Tierra Del Este Unit Eighty Two REVISED

City of El Paso — City Plan Commission — 10/18/2018

SUSU17-00047 — Resubdivision Preliminary

PROPOSED

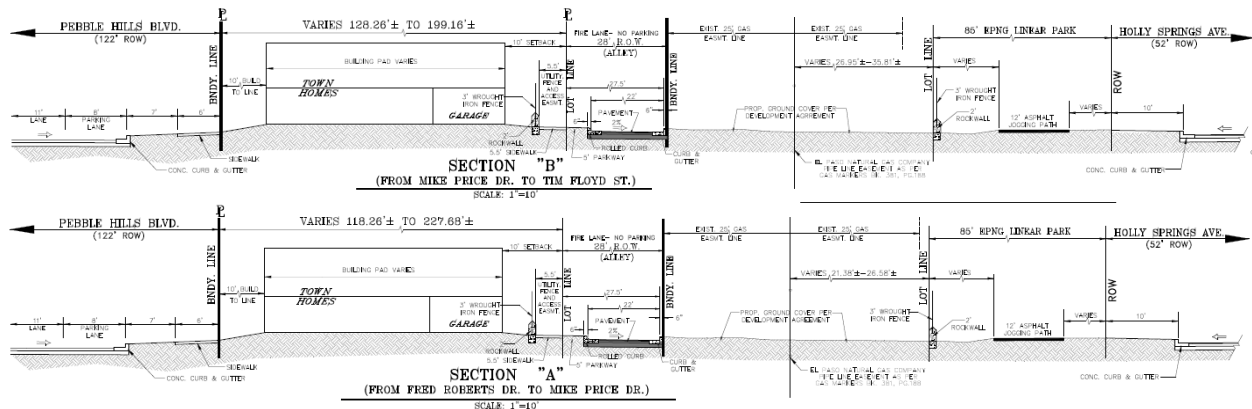
- To allow for an alternative design for the 28' alley which includes a 5' parkway and 22' of pavement.

ESD is good with the revised plat and alternative design that includes the 28' ROW (alley), and the abutting 5.5' utility easement. We also requested that signage be required in the alley per Title 12 indicating that the ROW is a fire lane/tow away zone.

We have reviewed the revised alley cross-section alternative design and have no further comments.

ATTACHMENT 2

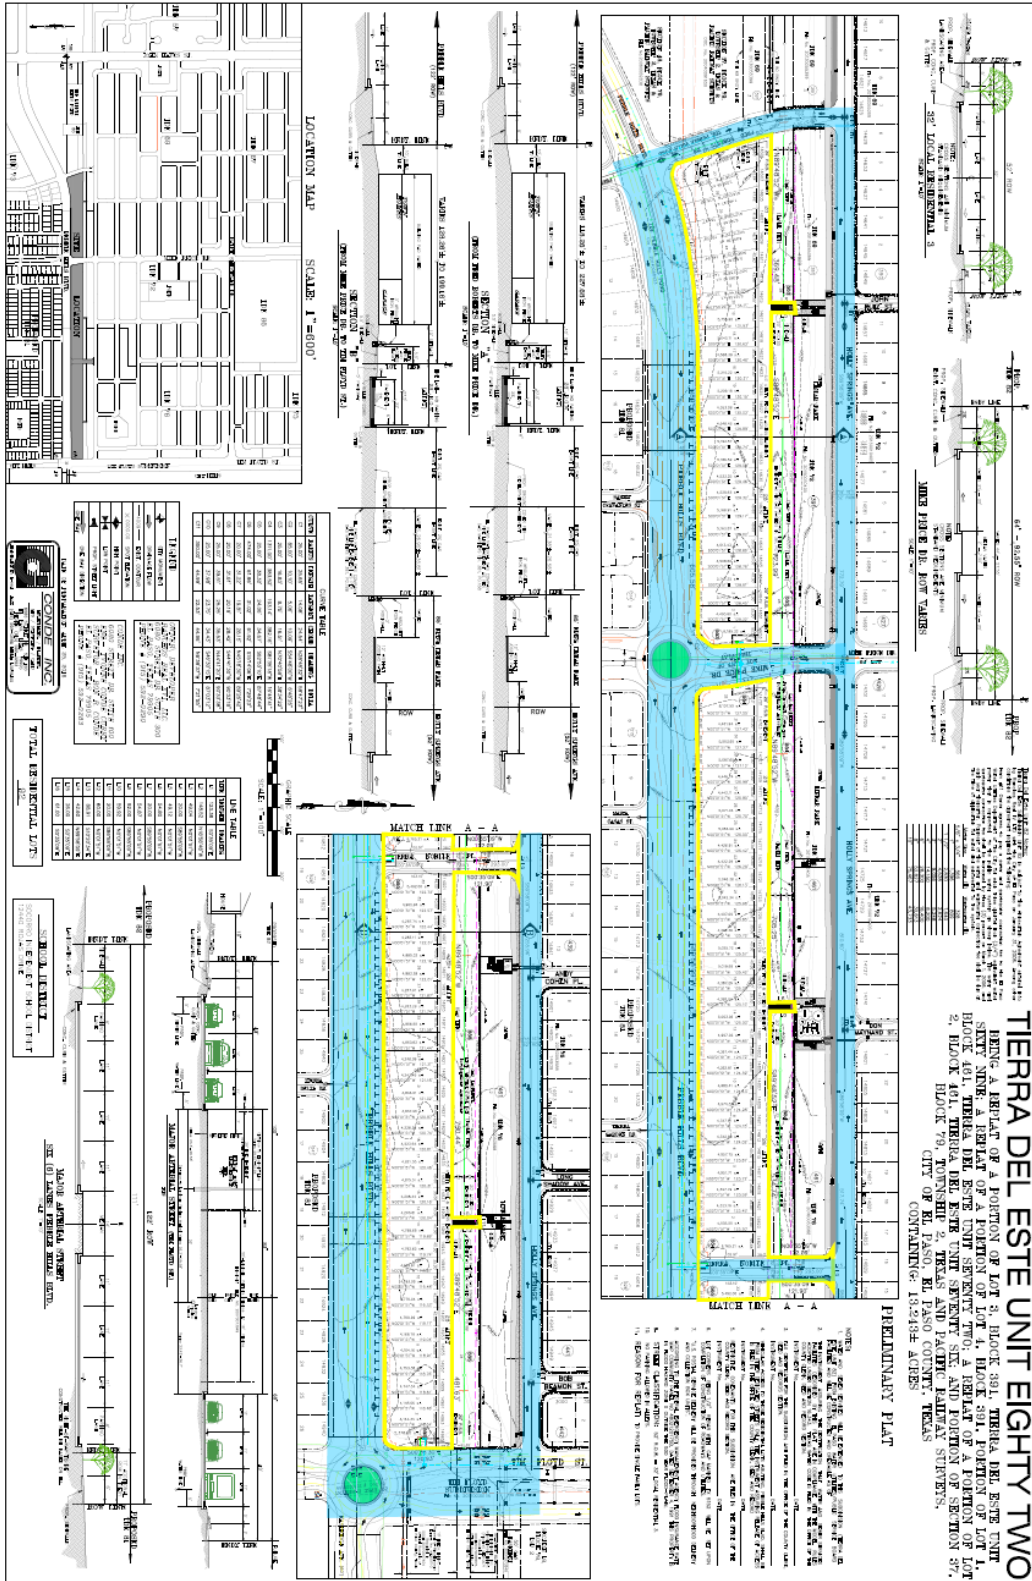
- Submit to the Planning & Inspections Department – Planning Division the following prior to recording of the subdivision:
 - a: Current certificate tax certificate(s)
 - b: Current proof of ownership.
 - c: Release of access document, if applicable.
 - d: Set of restrictive covenants, if applicable.
- Every subdivision shall provide for postal delivery service. The subdivider shall coordinate the installation and construction with the United States Postal Service in determining the type of delivery service for the proposed subdivision. In all cases, the type and location of delivery service shall be subject to the approval of the United States Postal Service.
- Verify and revise the date of preparation on the preliminary plat.

1. As per Tierra Del Este Unit 69, 72, & 76 Drainage Plans, the subject subdivision is to discharge into their proposed ponds; all downstream storm water management facilities should be in place prior to development of this development.
2. Show the drainage flow pattern within the alleys.
3. Show and label designated ponding destination(s).

The existing stub-outs are available for main extensions. The easements to accommodate the extensions are to be labeled PSB Easements instead of Utility Easements. A rock wall shall be constructed at the easement line that is within the lot.
